# Access Compliance Report

## Public Rights-of-Way

Intersection ID: 15069	Main Street: BRUNSWICK_AV	Cross Street: MEDICAL_CENTER_DR	Location: NW
ADA ID: F22194BDE6CD	Ramp Type: PerpDiag	Initial Pass/Fail: Fail	Overall Compliance: No
		Severity Score: 25

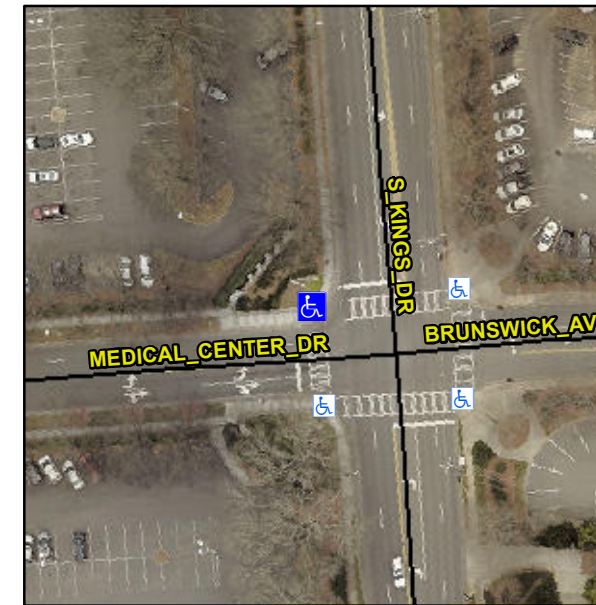
**Not Found, R304.2.2**

Compliance	Description	Data	Compliance	Description	Data
N/A	Ramp Length (in)	60.0	No	Ramp Slope (%)	13.6
Yes	Ramp Width (in)	48.0	Yes	Ramp XSlope (%)	2.0
N/A	Flare Type LT	N/A	N/A	Flare Type RT	N/A
N/A	Flare Slope LT (%)	N/A	N/A	Flare Slope RT (%)	N/A
N/A	Flare Traversable LT?	N/A	N/A	Flare Traversable RT?	N/A
N/A	Landing Length (in)	N/A	N/A	DWS Provided?	N/A
N/A	Landing Width (in)	N/A	N/A	DWS Contrast?	N/A
N/A	Landing Slope (%)	N/A	N/A	DWS Length (in)	N/A
N/A	Landing X Slope (%)	N/A	N/A	DWS Full Width?	N/A
N/A	Landing Curb? (Y/N)	N/A	N/A	DWS Offset (in)	N/A
N/A	Shared Landing?	N/A			
N/A	Gutter Ponding?	N/A	N/A	Gutter Slope (%)	N/A
N/A	Gutter Lip Ht (in)	N/A	N/A	Gutter X Slope (%)	N/A
N/A	Painted X Walk1?	Yes	N/A	Painted X Walk2?	Yes
	X Walk 1 Direction	To S		X Walk 2 Direction	To E
N/A	X Walk 1 Width (in)	108.0	N/A	X Walk 2 Width (in)	108.0
	X Walk 1 Slope (%)	2.7		X Walk 2 Slope (%)	0.6
	X Walk 1 X Slope (%)	2.9		X Walk 2 X Slope (%)	0.9

**Remove & Replace Curb Ramp With Two New Directional Ramps or Equivalent.**
